Environment Agency

Decision document recording our decision-making process following review of a permit

The Permit number is: EPR/FP3139FN/V009

The Installation is: Stanlow Manufacturing Complex

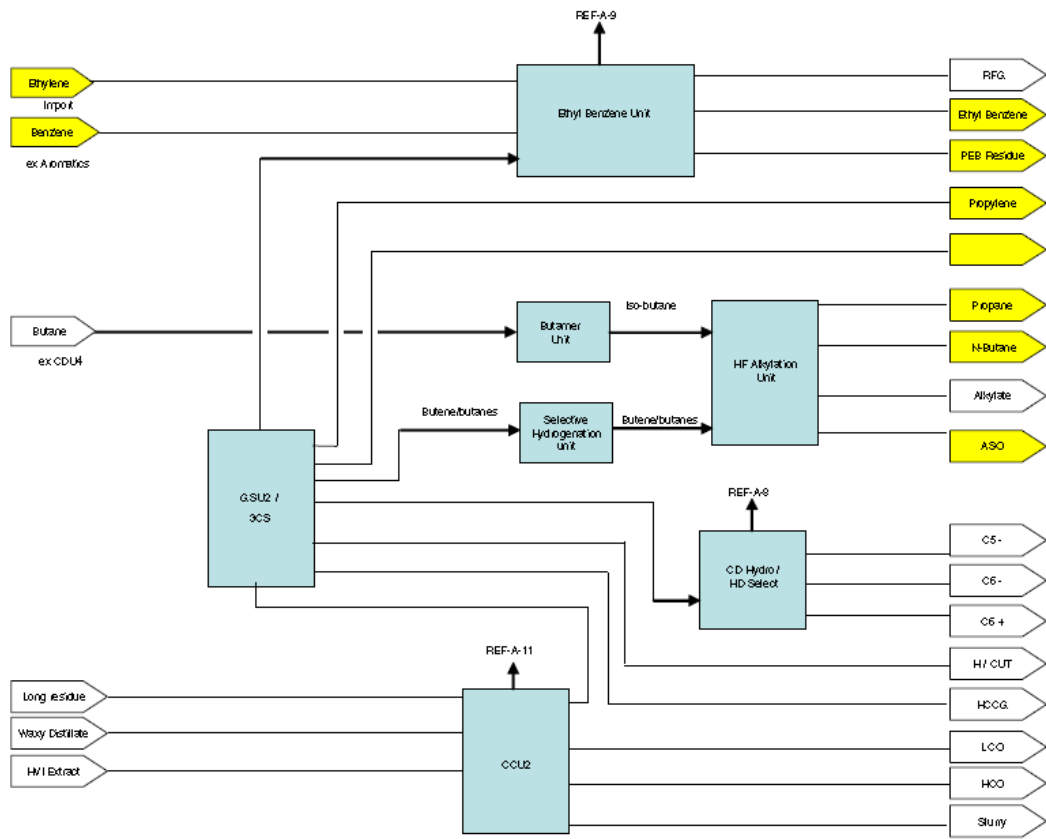
<p>published in 2016; based on a dataset gathered from European refineries, shows significant mercury emissions from combustion and cracking.</p> <p>Although there is no requirement to monitor emissions to air of mercury under the Refining Mineral Oil and Gas BREF, reporting of annual mass is required for the pollution inventory. Measurement of Hg in the RFG will be indicative of the quantity of mercury emissions to air, recorded by the pollution inventory.</p>
Reporting	
Table S4.1	updated in accordance with the current permit template and to include all relevant parameters and emissions
Reporting forms	
Table S4.5	updated to include all relevant forms
Schedule 6 Interpretation	
Emissions to land	added
Hazardous property	amended
Schedule 7 Site plan	
Installation boundary	amended to include White Oil Docks and to remove areas of land previously included in error
